**HOLTEC INTERNATIONAL**

**HI-STORM 100 SYSTEM  
CERTIFICATE OF COMPLIANCE 72-1014**

**LICENSE AMENDMENT REQUEST 1014-2**

**Holtec Response to Request For Additional Information  
Holtec International HI-STORM 100 Amendment Request, TAC L23564  
License Amendment Request 1014-2, Revision 1, Docket 72-1014**

FIGURE 2.1.2D; HOLTEC DAMAGED FUEL CONTAINER  
 FOR PWR SNF IN MPC-32/32F

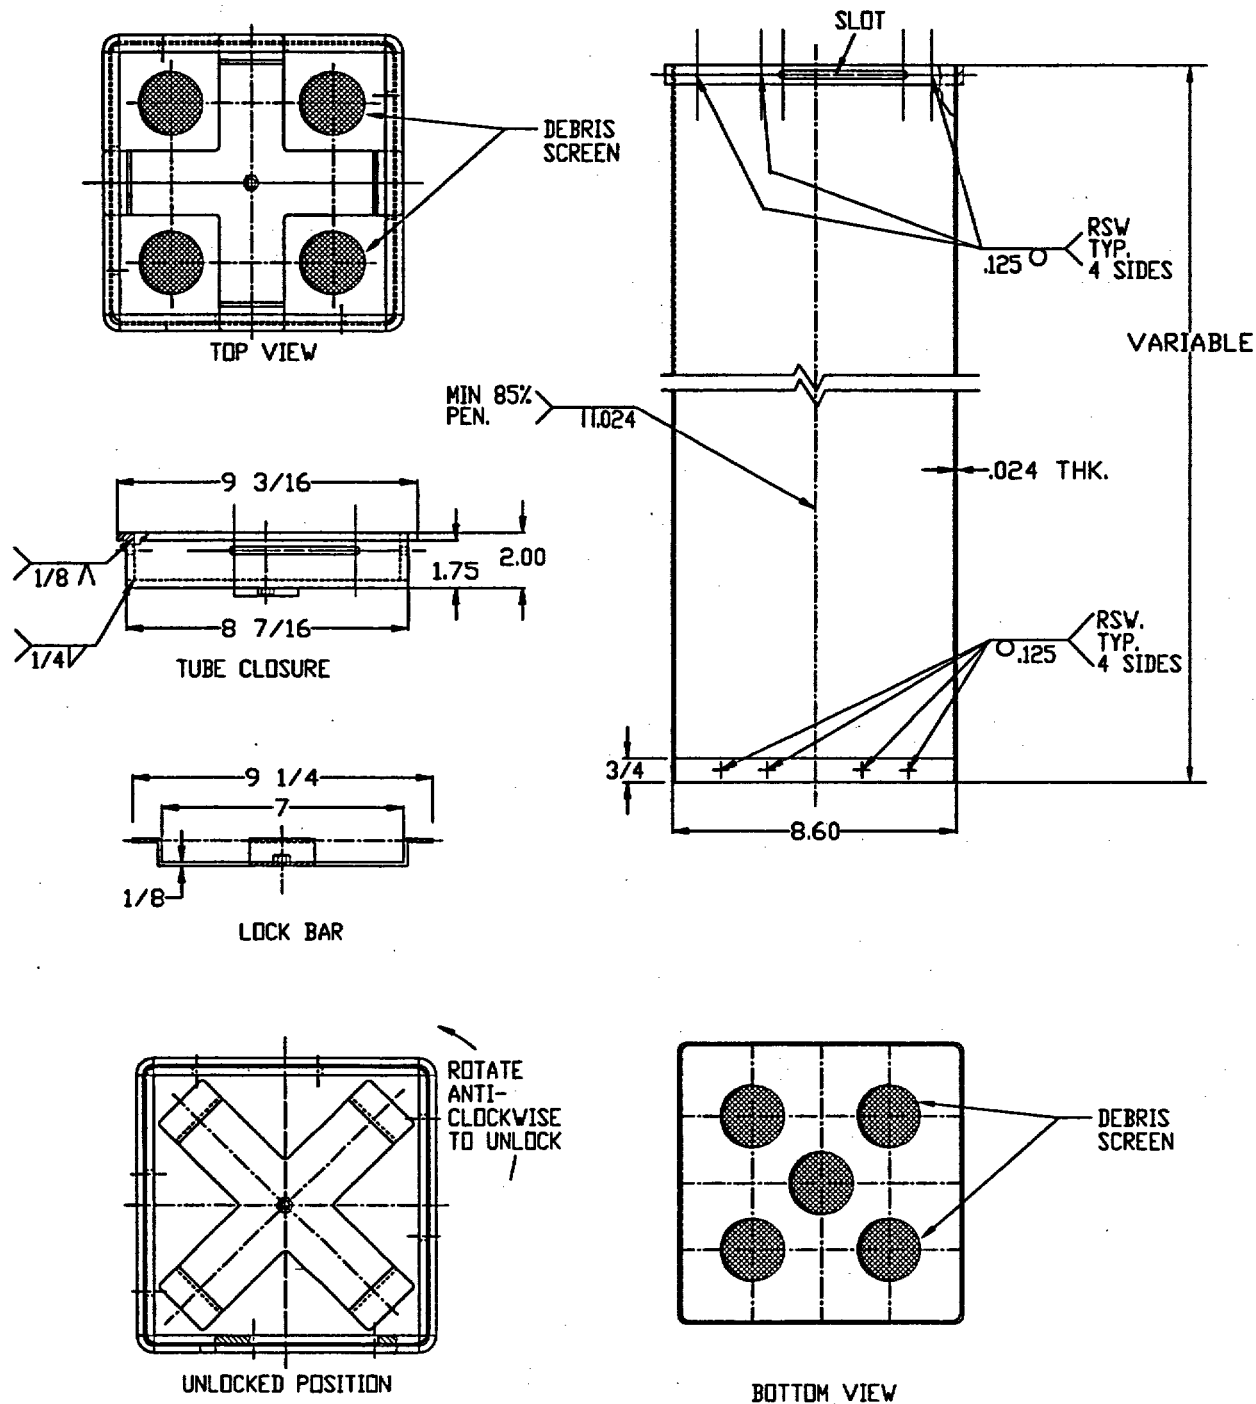
Section 2.1.3 notes that the DFCs for the Multi-Purpose Canister (MPC) 32F that is proposed in Amendment 2 are stainless steel and are provided with 250 x 250 fine mesh screens. Figure 2.1.2D provides some related information on the DFCs in terms of general dimensions and design concept, however Table 2.2.6 that lists the Materials and Components of the HI-STORM 100 System does not address the DFC, its components or its safety class. This relates to the HI-STAR 100 (Docket 71-9261) Amendment 1 Request, RAI 1-2, dated February 25, 2003.

The Holtec-designed Damaged Fuel Containers (DFCs) and the previously-approved Transnuclear-designed DFCs for Dresden Unit 1 fuel are structural components that are required to maintain the damaged fuel and fuel debris in an analyzed configuration under normal and accident conditions of storage. Drawings of the Holtec DFCs were removed, with SFPO's consent, from the HI-STORM FSAR as part of Amendment 1. Instead, appropriate design information was added to the DFC figures in the FSAR (Figures 2.1.1 through 2.1.2C). FSAR Figure 2.1.2D was proposed to be added for the MPC-32 DFC in this amendment request, to be consistent with this licensing approach.

In response to this question, we have re-reviewed all DFC figures in the FSAR to ensure they include key design information, such as dimensions, materials of construction, and design codes. Figures 2.1.1 and 2.1.2D were updated accordingly. Furthermore, we should note that the DFC's characteristics currently listed in Revision 1 of the HI-STORM FSAR, Table 2.2.6, include information such as the safety class, applicable design code, and materials. The codes applicable to the material, design, fabrication, and inspection of the DFCs are also listed in FSAR Table 2.2.7. For clarity, Table 2.2.6 has been enhanced to clarify the material specification and the applicability of ASME Section III, Subsection NG. We have also created new FSAR Section 3.4.4.3.1.9 to include a summary of the DFC structural analyses and results. [The details of these structural analyses can be found in Holtec Report HI-2012787, Revision 4, Supplements 24 and 25. Revision 3 of this report was previously submitted to the NRC on this docket on November 3, 2002. Revision 4 of this report was submitted to the NRC on Docket 71-9261 on May 29, 2003.]
